SUBJECT: RESULTS OF AUGUST 17, 1984 MEETING TO DISCUSS THE DETAILED
CONTROL ROOM DESIGN REVIEW OF NINE MILE POINT NUCLEAR
STATION, UNIT 1

NUCLEAR REGULATORY COMMISSION
STAFF COMMENTS
RESULTING FROM A BRIEFING
ON THE
NINE MILE POINT NUCLEAR STATION, UNIT 1
DETAILED CONTROL ROOM DESIGN REVIEW

C.10.F. Flow of Assessments/Resolutions

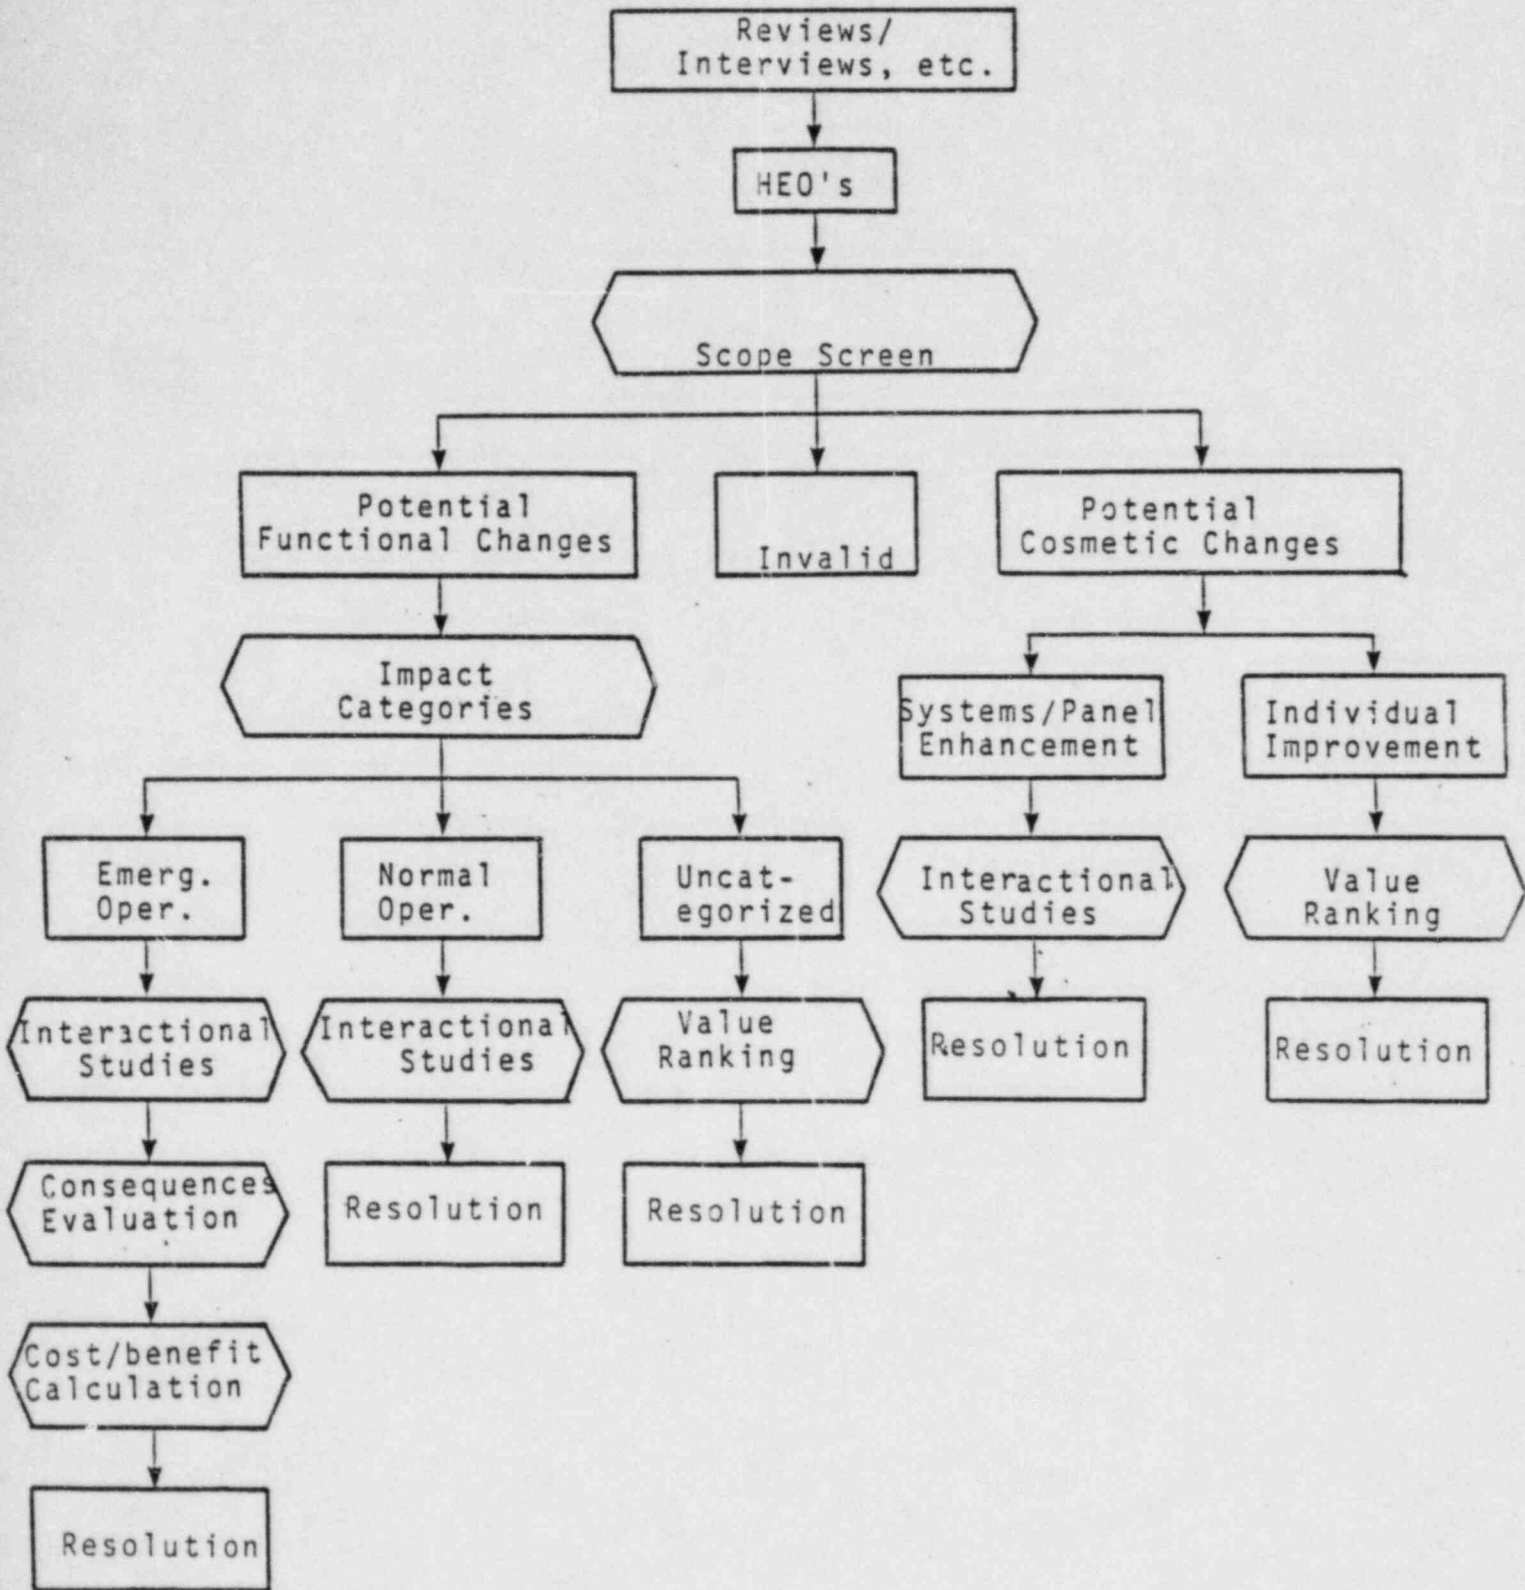
NMPC plans to consider potential corrective actions in the process for assessing human engineering discrepancies (HEDs) to determine which are significant and should be corrected. In the staff's judgment, assessment should be based on the potential for error associated with an HED and the consequences of such an error. The decision about whether or not an HED is significant should not be compromised by consideration of the means for resolving that HED.

The selection of design improvements process ("project initiation" in NMPC terms) was briefly discussed. In the staff's judgment this task should be organized to produce an integrated set of corrective actions (i.e., a set of corrective actions providing the operator with a consistent, coherent, and functionally adequate control room interface). Based on the August 17, 1984 briefing, the staff is uncertain whether plans adequate to accomplish this task have been developed.
